UNITED STATES PATENT AND TRADEMARK OFFICE

APPLICATION NO.	FILING DATE	FIRST NAMED INVENTOR	ATTORNEY DOCKET NO.	CONFIRMATION NO.
10/574,881	04/06/2006	Martinus Jacobus Coenen	NL03 1229 US	1731
65913	7590	02/07/2008		
NXP, B.V. NXP INTELLECTUAL PROPERTY DEPARTMENT M/S41-SJ 1109 MCKAY DRIVE SAN JOSE, CA 95131			EXAMINER CLARK, JASMINE JHIHAN B	
			ART UNIT 2815	PAPER NUMBER
			NOTIFICATION DATE 02/07/2008	DELIVERY MODE ELECTRONIC

Office Action Summary	Application No. 10/574,881	Applicant(s) COENEN, MARTINUS JACOBUS	
	Examiner Jasmine J. Clark	Art Unit 2815

FIG. 2

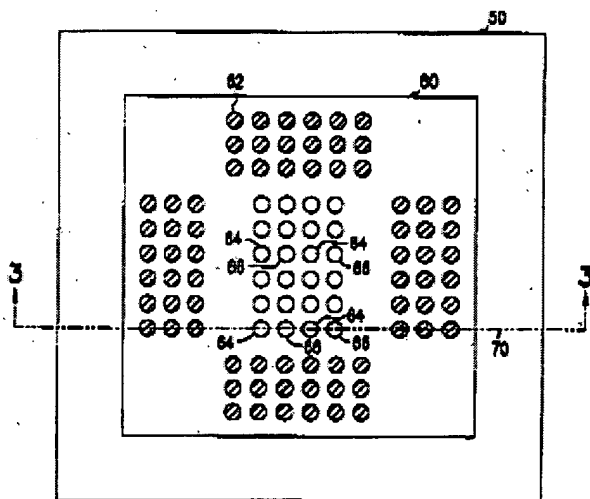
a semiconductor device providing with a plurality of bond pads, of which bond pads a first portion is defined for ground connection and a second portion is defined for voltage supply (see paras [0028], [0029] and [0030]) and a third portion is defined for signal transmission (see para [0033]), and a carrier substrate (50) comprising a layer of dielectric material (see para [0020]) and having a first side and an opposed second side, the first side and the opposed second side are each provided with an electrically conductive layer, on which first side bond pads are present corresponding to the bond pads of the semiconductor device, and on which second side contact pads (109, ie.,) for external coupling are provided, the contact pads and the bond pads being subdivided into a first, a second and a third portion corresponding to the portions of the

semiconductor device, the first and second portions of the bond pads being present laterally in an inner area (areas of solder balls 64 and 66 disposed) and the third portion (areas of solder balls 62 disposed) being present in an outer area around the inner area, wherein the semiconductor device is coupled to the carrier substrate in a flip-chip orientation, and the bond pads and the contact pads for voltage and ground connection (V_{cc} and V_{ss}) are located correspondingly, so as to provide a direct path from the contact pads at the substrate to the corresponding bond pads of the semiconductor device, and the pads of the first and second portions (116, 121 and 125, for example) are arranged such that at least one direct dedicated to voltage supply connection acts as a coaxial center conductor.

Concerning claim 3 and 4, wherein the pads for ground and supply connections are arranged according to a chessboard pattern (see Fig. 2 above), and wherein a layer of dielectric material (81 and/or 95, i.e.) (see paras [0033] and [0036]) extends from the first to the second side in the substrate.

FIG. 3

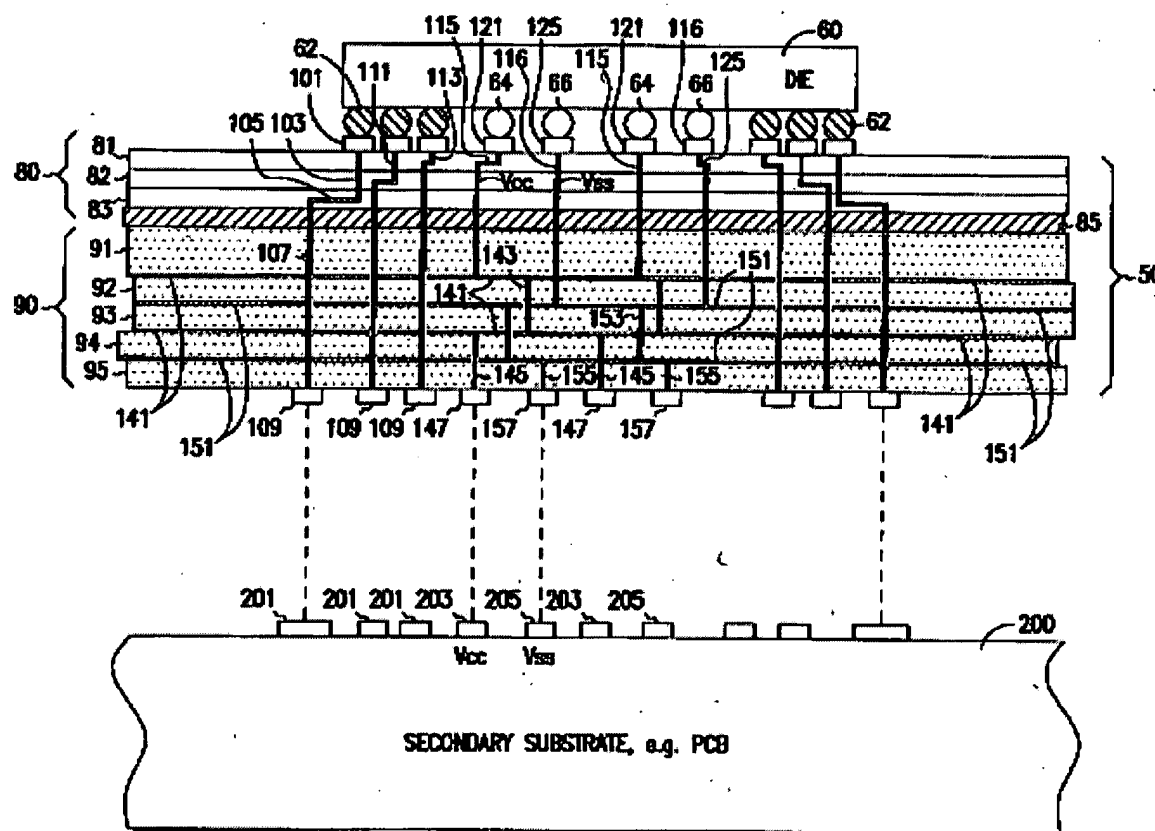
Concerning claims 5 and 6, an electronic device as claimed in claim 1, characterized in that the bond pads of the third portion and the corresponding contact pads (through 109, i.e.) for external coupling are interconnected through; interconnects defined in the conductive layer on the first side of the carrier substrate (50), and vertical interconnects through the carrier substrate (50) which, in the case of perpendicular projection on the conductive layer on the second side, have a substantial overlap with the contact pads for signal transmission (at least at an internal region of the third portion, see Fig. 3 above). Furthermore, an electronic device as claimed in claim 5,

characterized in that a ground plane (V_{cc} and V_{ss}) is defined in the conductive layer on the second side (i.e., 147 and 157) of the carrier substrate (50), and the mutual distance between the interconnects and the dielectric thickness of the carrier substrate are chosen such that the interconnects have transmission line characteristics. For the reason that the limitations of claim 10 are similar to claim 1, please see the above discussion.
